Gate Burton Energy Park EN010131

Applicant Response to ExA First Written Questions
Document Reference: 8.6
August 2023

Rule 8(1)(b)
Planning Act 2008
Infrastructure Planning (Examination Procedure) Rules 2010

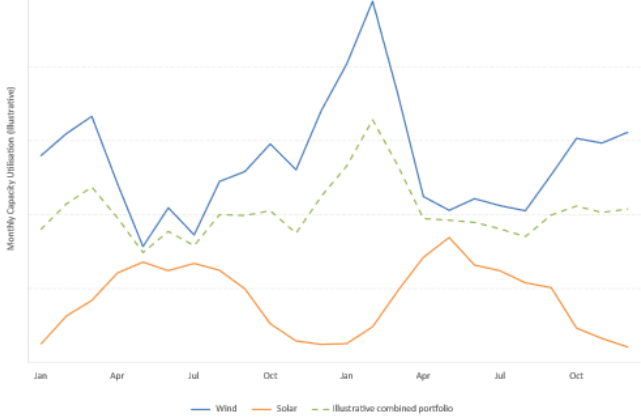
ExQ	Respondent	Question	Applicant's Response
Q1.1.8	Applicant	<p>accord with the requirements of the Public Sector Equality Duty.</p> <p>Generation Capacity Dependability</p> <p>Figure 8.1 of the Statement of Need [APP-004] shows Illustrative Generation Capacity Dependability for a combined portfolio of solar and wind in Great Britain, with some supporting commentary in paragraphs 8.8.4 to 8.8.9.</p> <ol style="list-style-type: none"> 1) Provide further details of the methodology and evidence used in providing Figure 8.1 [APP-004], including the number, proportion, size and location of solar and wind generating assets used in its formulation. 2) What level of certainty can there be that the conclusions derived from Figure 8.1 [APP-004] are typical for solar and wind installations as a whole? 	<p>1) The data for the graph at Figure 8.1 of the Statement of Need [APP-004/2.1] is sourced from National Grid's Demand Data and Actual Metered Generation files. These are large datasets which the Applicant can provide if the ExA confirms that to be its preference.</p> <p>The Demand Data files include National Grid's estimated output, and capacity, for unmetered wind and unmetered solar generation.</p> <p>The Actual Generation file includes metered wind generation (but not installed capacity). National Grid's Future Energy Scenarios includes a workbook which estimates installed wind capacity by year. This data and data available from National Grid's Transmission Entry Capacity (TEC) Register, has been used by the author to derive a series of historical metered wind capacity. This is also a large dataset which the Applicant can provide if the ExA confirms that to be its preference.</p> <p>The data series shown in Figure 8.1 is therefore derived from the data, and data points are interpolated to derive an estimated actual capacity operational in each month. Two load factor series can therefore be calculated: one for solar, and the other for the combination of metered and unmetered wind.</p>

ExQ	Respondent	Question	Applicant's Response
			<p>Figure 8.1 of the Statement of Need [APP-004/2.1] shows the load factor series for each of wind and solar respectively as the blue and orange lines. The green dashed line is the weighted average load factor for the combined national portfolio of wind and solar i.e., (wind generation + solar generation) / (wind capacity + solar capacity).</p> <p>The analysis behind Figure 8.1 of the Statement of Need uses national-level data from 1 January 2017 to 31 December 2018, and therefore represents a national-level position covering micro wind, onshore wind and offshore wind as well as rooftop, commercial and larger scale ground mounted solar to a total combined portfolio of approximately 20GW of wind and 13GW of solar (estimated at year end 2018). The solar and wind generation facilities included in this portfolio are located throughout the UK.</p> <p>2) By virtue of the analytical methods employed, Figure 8.1 of the Statement of Need [APP-004/2.1] is an illustration of Generation Dependability. Future “actuals” will be dependent on weather conditions at the time, as well as updated estimates of installed generation capacity across the wind and solar sectors over different time periods.</p> <p>Figure 8.1 therefore seeks to show that by combining two generation portfolios which are largely independent of each other (meaning, the level of solar generation in the UK at any time is not mathematically dependent on the level of wind generation in the UK at that time, and vice-versa) the variation of the combined portfolio of (solar + wind), when</p>

ExQ	Respondent	Question	Applicant's Response
			<p>averaged over a period of time, is lower than the variation of each of the portfolios separately, although the Applicant notes that not all individual days will always conform to this observation.</p> <p>The Applicant concludes that the level of certainty which may be ascribed to the general conclusions made is high, based on historical information, and expects that insofar as solar and wind capacity both increase in the future in broadly similar proportion to each other as has been experienced historically, then the conclusions will remain valid in the future.</p> <p>As an illustration of this, the figure below replicates the analysis behind Figure 8.1 of the Statement of Need [APP-004/2.1] using the same data and methodology but uses a different data set, covering 1 January 2019 to 31 December 2020. In the resulting figure (shown below), the observation noted in Paragraph 8.8.6 of the Statement of Need [APP-004], that “<i>Generation Dependability is improved when diverse RES technologies are deployed alongside each other in the same electricity system: the green dashed line is always between the blue and orange lines and is flatter than the other two lines, showing a lower variation from month-to-month through the year</i>” remains valid.</p>

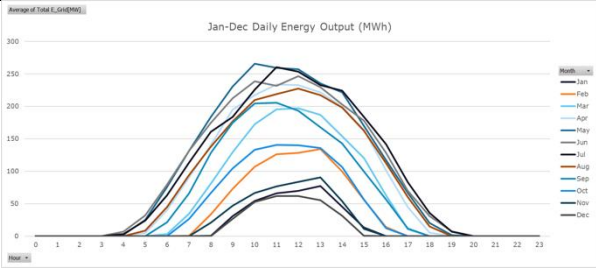
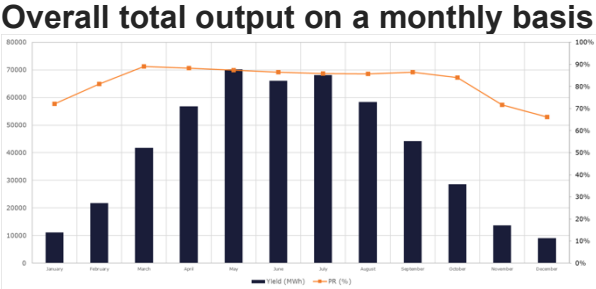
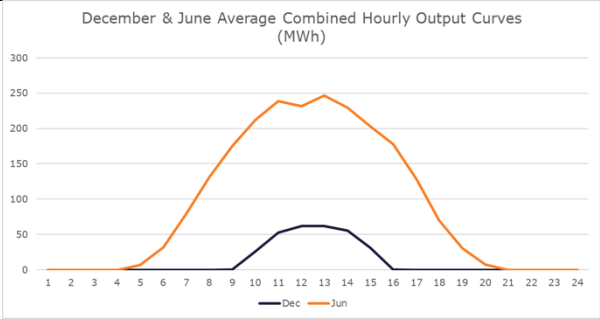
ExQ	Respondent	Question	Applicant's Response
			<p>6. AD should be proportionate to the nature and scale of the principal development. The scale of the BESS is proportionate to the solar PV.</p> <p>7. In most cases it should be typical of development brought forward alongside the relevant type of principal development. Precedent includes the Hornsea Four Offshore Wind Farm Order 2023 and the Longfield Solar Farm Order 2023.</p> <p>Further detail on compliance with the Associated Development Guidance is in section 6.2 of the Planning, Design and Access Statement Part 2 [APP-005/2.2].</p>
Q1.1.15	Applicant	<p>Energy production from the solar panels In the Grid Connection Statement [APP-232] paragraph 4.1.1 states that “The Scheme will generate electricity and transmit it to the System Operator (National Grid Electricity System Operator (NGESO))....” And at paragraph 4.14 it states “As such, the Applicant confirms that output of the Solar and BESS will be exported via the NETS”, but no figures are provided. Bearing in mind the pace of technological change, including solar panel types, materials and configurations; and conversion efficiency from the Direct Current (DC) panels to inverters and inverters to Alternating Current</p>	<p>i. Solar cell (*) energy yields vary significantly over hourly and daily periods during the calendar year and are subject to environmental, climatic and seasonal conditions as well as grid system availability. Monthly and seasonal outputs can be statistically simulated and as a result average hourly or daily outputs can be computed but instantaneous outputs cannot be guaranteed and will vary due to weather conditions and the factors mentioned above. To illustrate seasonal variability, below are charts indicating average simulated daily outputs from December to June, and overall total output on a monthly basis.</p> <p>January to December Average Daily Energy Output</p>

ExQ	Respondent	Question	Applicant's Response
		<p>(AC) output to the national grid can the Applicant address the following matters:</p> <p>i) How much energy is it expected that the solar cells to produce daily?</p> <p>ii) At what times of day?</p> <p>iii) Is there hourly projections available of likely energy production by time of day and time of year?</p> <p>iv) How do these figures compare with other alternative sites investigated by the Applicant?</p> <p>v) What is the maximum storage demand that will be made on the BESS by the energy generated by the solar panels?</p> <p>vi) Is the BESS able to deal with this demand? and,</p> <p>vii) What is the export limit both as DC from the solar panels and as AC into the national grid?</p>	 <p>Overall total output on a monthly basis</p>  <p>(*) The figures used in this response consider the usable energy exported or injected into the grid, not the energy generated at the solar PV panels. In a solar PV plant DC power is generated by solar PV panels and converted to AC power by inverters and converted from low voltage to high voltage by transformers and transported over DC, AC and MV cables, all of which include conversion or efficiency losses.</p> <p>ii. Average hourly predicted outputs vary seasonally, below are average predicted hourly outputs for December (lowest typical generation) and June (highest typical generation)</p>

ExQ	Respondent	Question	Applicant's Response
			 <p data-bbox="1218 603 2074 1157"> iii. Yes, likely energy production can be forecast based on Typical Meteorological Year (TMY) data used in solar PV plant simulations. As per previous responses, average expected hourly or daily outputs can be simulated but cannot be guaranteed due to instantaneous weather conditions. PV plant simulations include statistical exceedance probability calculations for assessing the confidence of forecasts </p> <p data-bbox="1218 938 2074 1157"> iv. Variations in specific energy yields (i.e. kWh/kWp) for projects located in the same geographic area are negligible. Differences are only observed when comparing projects in different parts of the country. Example of specific PV power output in a 42x42km square area around Gate Burton (3% variation). </p>

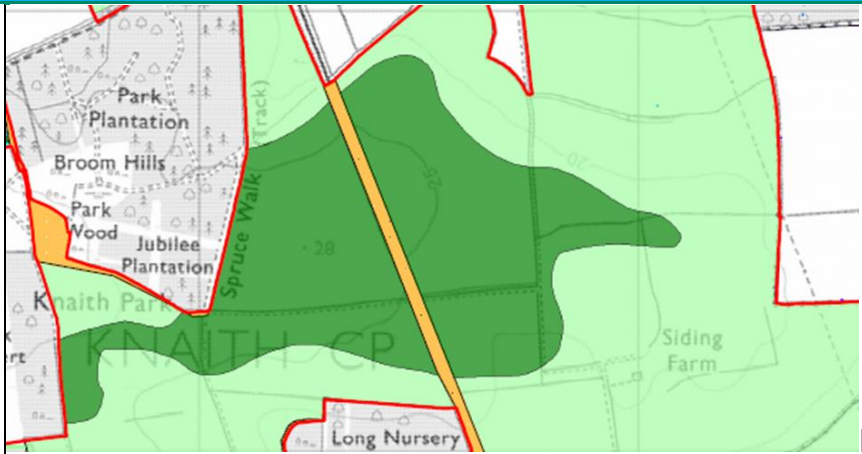
ExQ	Respondent	Question	Applicant's response
			<p>5) Question 5 asks about the loss of yield due to the Proposed Development. It is presumed that this question is asked in the context of the use of land that is of the Best and Most Versatile agricultural quality (BMV), as there is reference to the use of BMV in the draft NPS EN-3 paragraphs 3.10.15 and in 3.10.136 which advises that the Secretary of State should take into account the economic and other benefits of BMV agricultural land. There is no policy reference to non-BMV land.</p> <p>The BMV land within the Solar Energy and Storage Park is shown on Map 3 of the Agricultural Land Classification Report in Appendix 12-C of the ES [APP-162/3.3.]. Two small areas to the south are small areas within larger fields and are not capable of separate exploitation.</p> <p>The central block is shown on the insert below. This involves one complete field and a significant part of two others.</p> <p>The soils to the west of the railway are very sandy in this area, as shown below. The soil photographs are from the locations shown on the extract from the ALC plan below.</p>

ExQ	Respondent	Question	Applicant's response
			 <p data-bbox="2004 686 2049 718">Pit</p> <p data-bbox="1146 726 1176 758">1</p>  <p data-bbox="1146 1276 1612 1308">Pit 2: note the dryness of the soil</p>

ExQ	Respondent	Question	Applicant's response
			 <p data-bbox="1146 798 1937 869">East of the railway the land is heavier, as shown below. Pit 3: East of the railway</p>
